RE: BACT Revision (PSD-FL-224/Bartow Phosphoric Acid Plants 4 & 5)

Re: Cargill Fertilizer, Inc. - Bartow Facility
Phosphoric Acid Plants - Permit AC53-262532; PSD-FL-224

This is in response to KBN's February 1 letter submitting scrubber design calculations and explaining Cargill's position regarding the installation of a venturi/cyclonic vs. packed scrubber for the new Bartow phos acid filter (PSD-FL-224).

FILTER VENT SCRUBBER

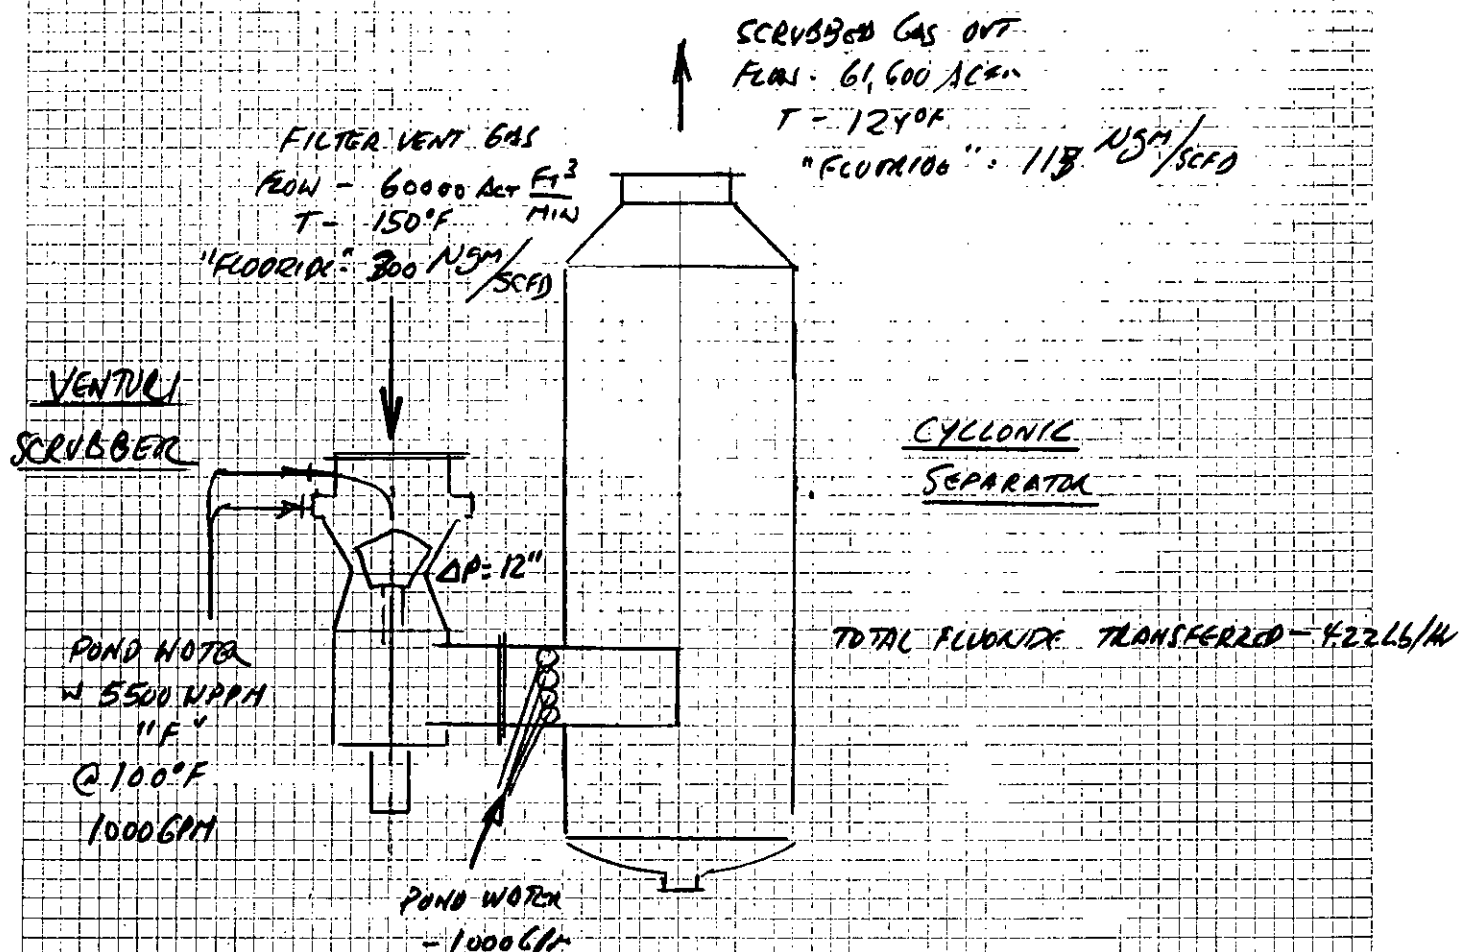
The Department received Cargill's March 7 letter and sketch showing that the newly-installed venturi/cyclonic scrubber will be modified by including a packed scrubbing section with a demister.

As per our telephone conversation on 3/5/96 with Mr. John Reynolds of your staff, Cargill agrees to modify our proposed venturi-spray-cyclonic scrubber by the addition of a packed section with the understanding that the Department will not conduct a new BACT determination.

The modified scrubber will consist of a venturi followed by a spray duct and cyclonic section as previously described to you with the addition of a new packed section and chevron mist eliminator following the separation zone of the cyclonic. A schematic of the proposed modifications is attached for you information. As discussed in our previous correspondence and during our phone conversations, we are confident that this scrubbing system will be able to achieve the 2.29 lb/hr fluoride emission limitation contained in the permit and, with the modification, that it meets the Department's requirements outlined in the BACT analysis

Since this modification resolves the Department's concerns regarding BACT, the emission limit revision mentioned in our March 4 letter is no longer necessary.

FIGURE 13 - THE EFFECT OF FLUORIDE CONCENTRATION ON THE SATURATED FLUORIDE CONCENTRATION IN AIR FROM SOLUTIONS OF GYPSUM WATER AND HF

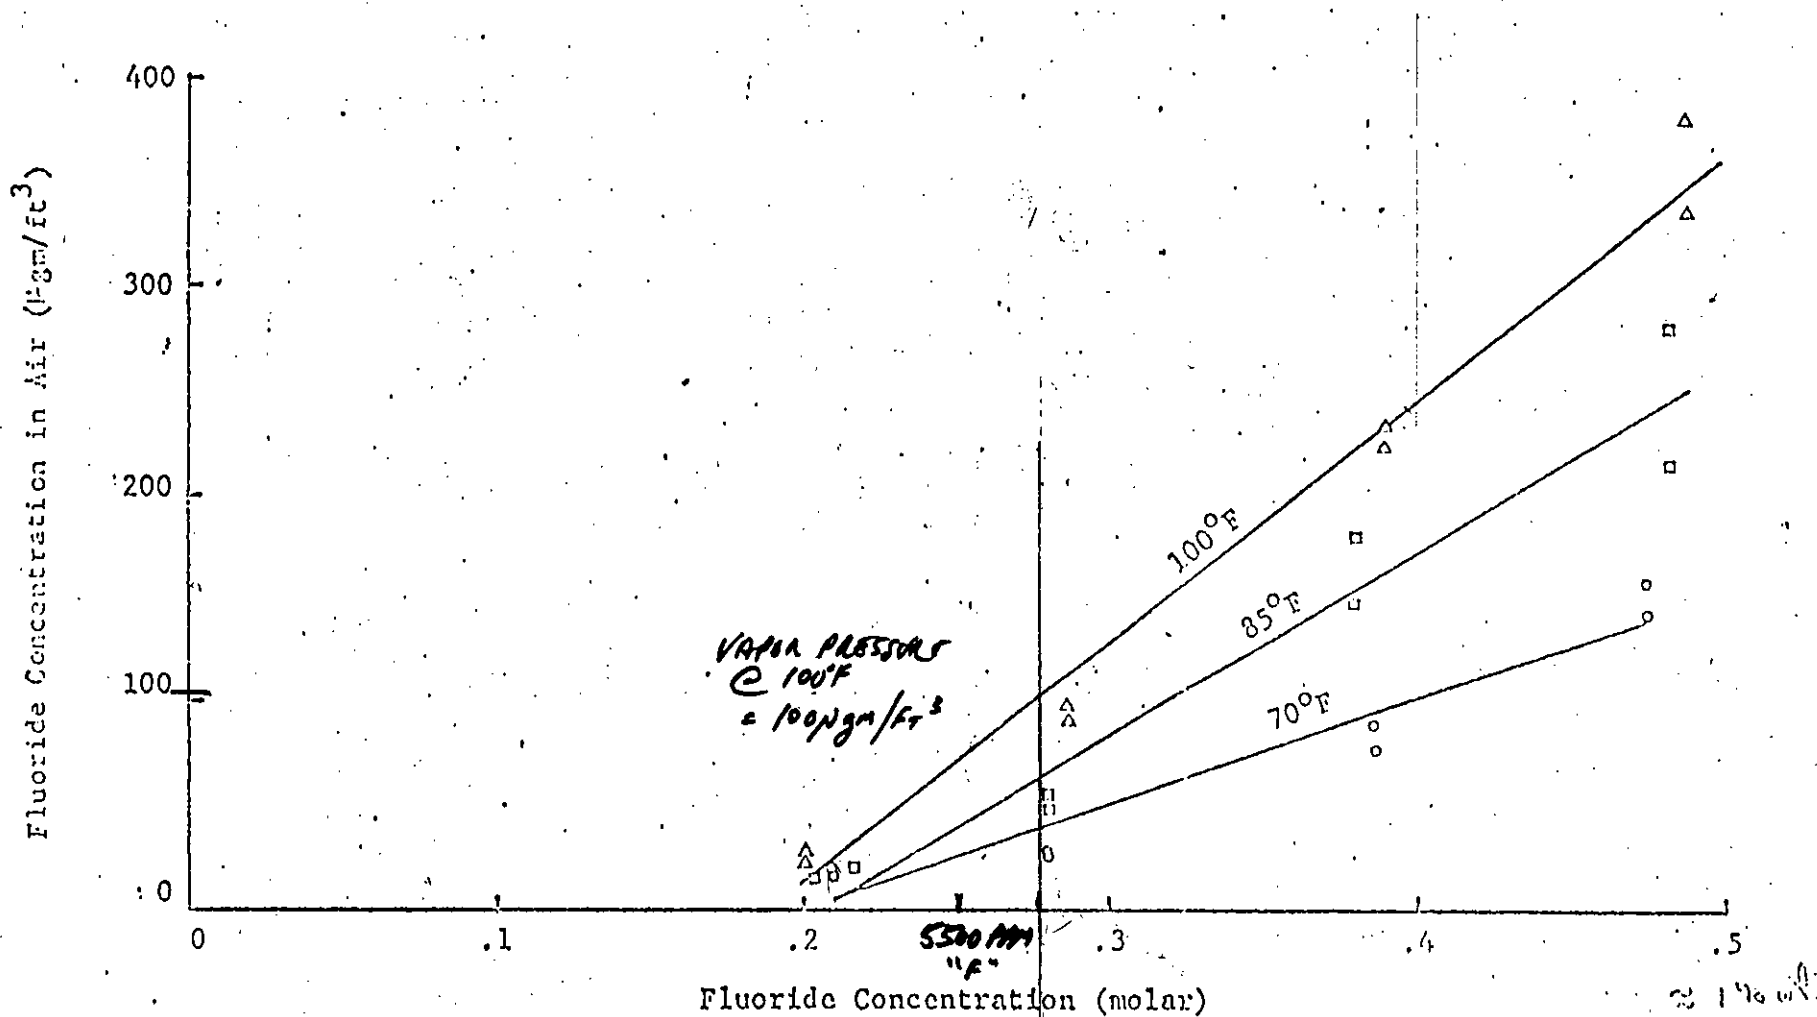
- ③ "IF" VAPOR PRESSURE OVER 100°F POND WATER @ 5500 PPM "F" IS 100 MICROGRAM / FT³ (SEE GRAPH). THIS REPRESENTS THE BACK PRESSURE OF "F" THROUGH THE SCRUBBER (OVER)

Figure 5. Variation of NTU with L/G ratio and V_g calculated from the empirical law. Using $T_{GE} = 60^\circ\text{C}$ and saturated gases; $L_v/D_c = 8.5$.

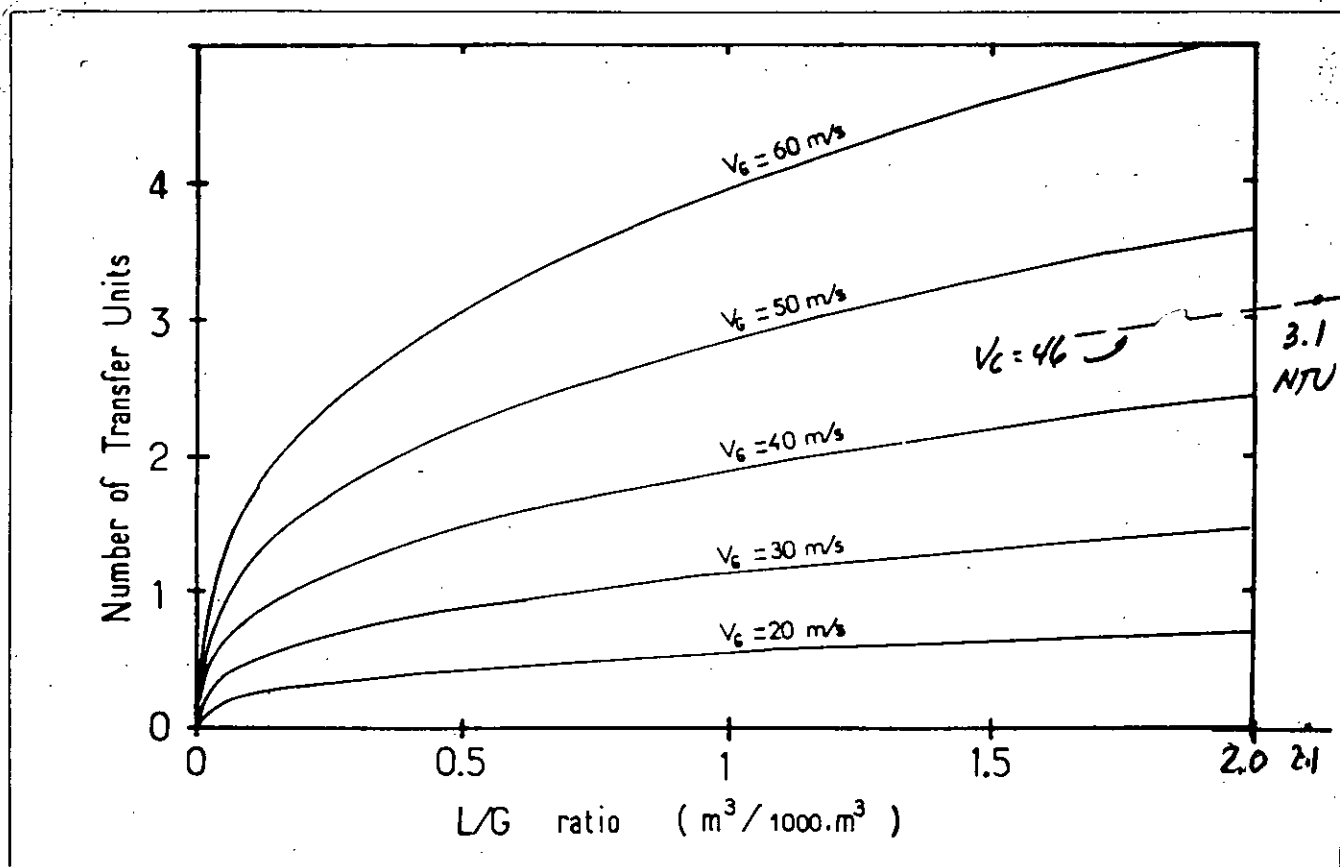
EXTRAPOLATING THE GRAPH IN FIGURE 5, THIS TYPE
OF OPERATION WILL YIELD 3.1 TRANSFER UNITS
